## D/DRC Case

204 Huger Street

**DESIGN/DEVELOPMENT REVIEW COMMISSION**  
**DESIGN REVIEW DISTRICT**  
**HISTORIC AGENDA**  
**EVALUATION SHEET**  
Case #7

**NATURE OF REQUEST:** Request for Certificate of Design Approval for changes to approved plans.

**LEFT ELEVATION**  
SCALE: 1/4" = 1'-0"

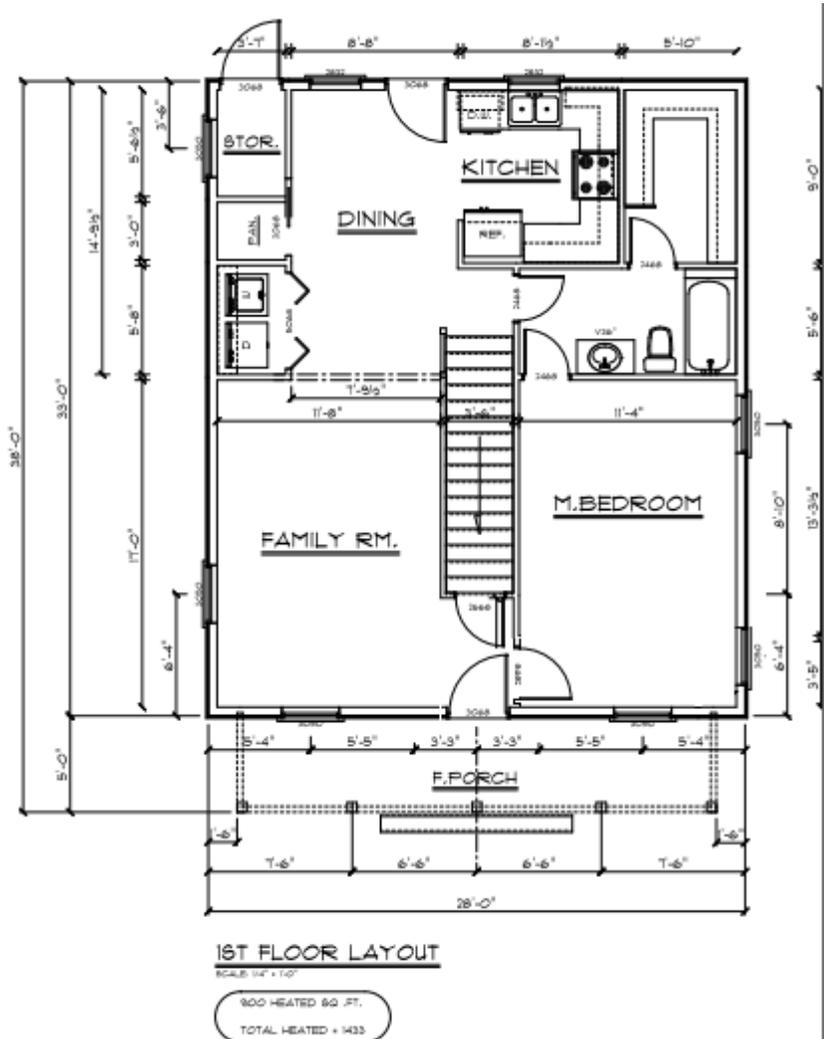
**Walls:** The proposal previously approved by the D/DRC in July featured smooth horizontal cement fiberboard siding with fascia, cornice, and corner boards constructed of wood or cement fiberboard products. As discussed earlier, the applicant would like to change the siding material from cement fiberboard to vinyl. Vinyl siding has never been approved for new construction in any Architectural Conservation District, and is not a preferred material in Granby. Horizontal wood siding and smooth cement fiberboard are the preferred materials for new construction. The vinyl siding proposed by the applicant does have a reveal that is relatively consistent with wood siding, but the overall look of the product does not replicate the look or construction details typically associated with wood or cement fiberboard siding. Vinyl is installed in sheets instead of individual boards, and the fastening components and channels are unique to the vinyl siding industry. In a side-by-side comparison, it is easy to distinguish the differences between a house clad in vinyl and one clad in wood or cement fiberboard. This house will be placed very close to the street, which would make vinyl siding even more noticeable.

**FRONT ELEVATION**  
SCALE: 1/4" = 1'-0"

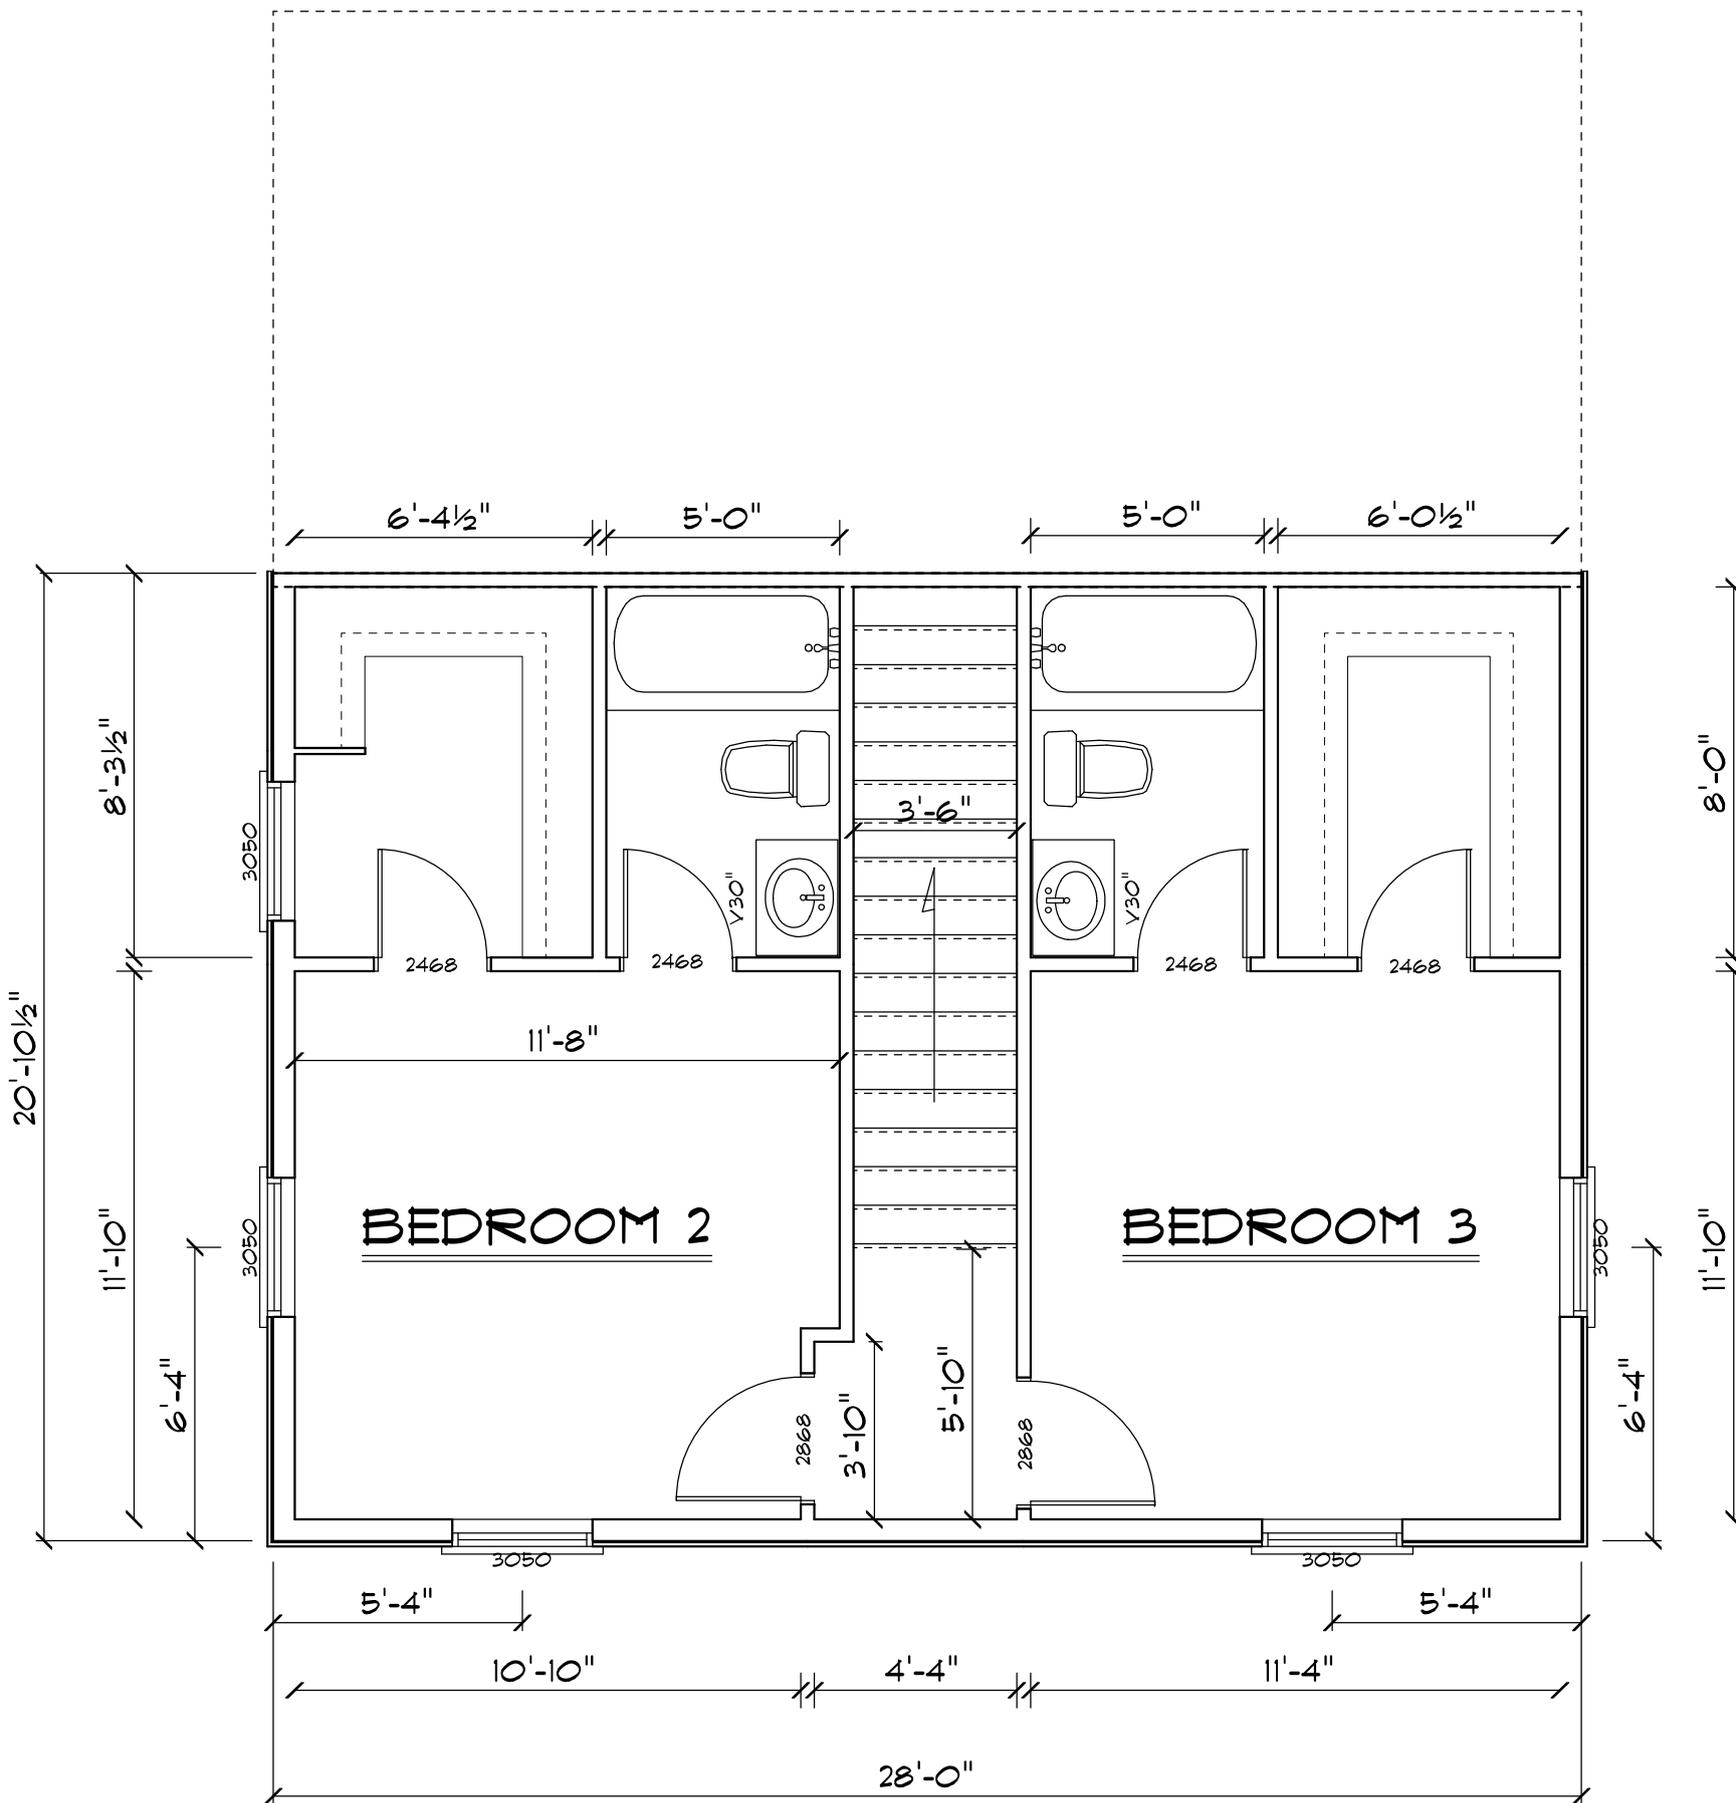
The original submission that was approved by the D/DRC in July featured a 1-story full-façade, shed roof porch with two doors and five simple square wood posts. This design was recommended by staff as it was the original configuration used when the historic saltbox duplexes were built in the 1890s. The applicant is now proposing to change the design from two doors on the façade to one and five porch supports to four. The guidelines are very clear about the two front doors being “duplicated even if a single family home is built.” As stated earlier, staff has discussed options with the applicant on how to keep the two door design while only having one functional door. A single, center door on the façade would visually conflict with a center porch support, which is why the applicant has reduced the total number of porch supports to four. The guidelines require new construction to mirror the character and continue the extreme consistency, which means that two doors and five porch supports on the façade would be the most compatible design solution. Therefore, a single entry door and four porch supports would not meet the guidelines.

**Doors:** The applicant's proposal to change from two doors to one does not meet the guidelines. Staff recommends two doors with a 4-panel or a half-glass over 2-panel design to be closer to the original configuration of the historic saltbox houses. One door may be a fixed or faux door to allow the interior floor plan to be uninterrupted.

**Porch columns:** The applicant's proposal to change from five porch supports to four does not meet the guidelines. Staff recommends five square wood porch supports as approved previously.

- Staff recommends changing the proposed design of the house back to the configuration previously approved by the D/DRC in July
- A revised design for a wood privacy fence may be approved at staff level
- All details deferred to staff.

Diagram showing original saltbox configurations

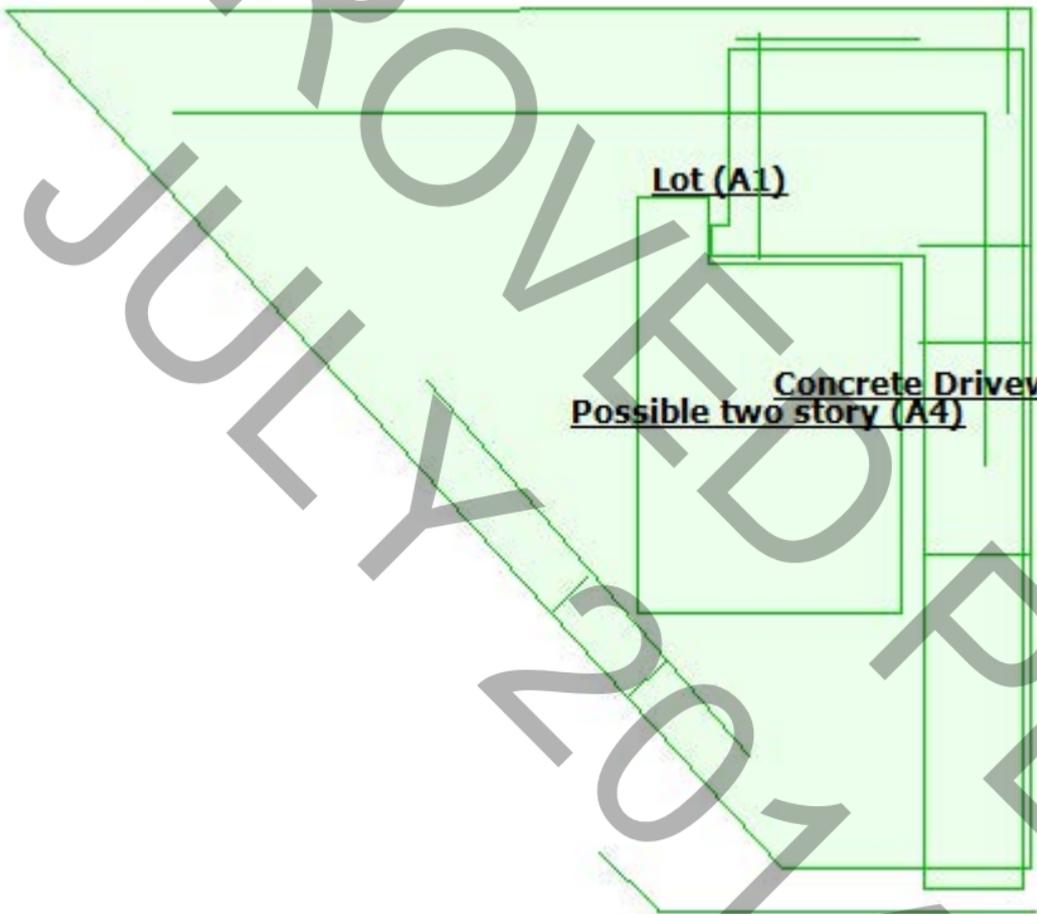
The proposed house features a 1-story full-façade, shed roof porch supported by five simple square wood posts. This configuration is based on the original saltbox houses found in the district. Although the house will be a single family residence, the proposal shows two front doors that are within the context of the saltbox style.

The side elevations show a 10/12 pitch for the primary roof and a similar pitch for the 1-story front porch shed roof; however, the façade elevation shows a lower pitched roof for the porch. The front porch roofs on historic saltbox houses in the district typically have a pitch that is closer to that of the primary roof. Staff recommends increasing the front porch roof pitch to be more visually compatible with other saltbox houses in the district and possibly using the one next door as an example.

- Setback of the house shall be flush with 200-202 Huger Street
- Smooth horizontal cement fiberboard siding shall be used with a reveal of approximately 4.5"
- Windows shall be 6/6 wood or aluminum-clad with 5/8" exterior muntins
- The front porch roof pitch shall be increased to be more visually compatible with historic saltbox houses in the district
- Front doors shall be wood or insulated fiberglass with a 4-panel design, or a half-glass over 2-panel design with optically clear glass
- All details deferred to staff.
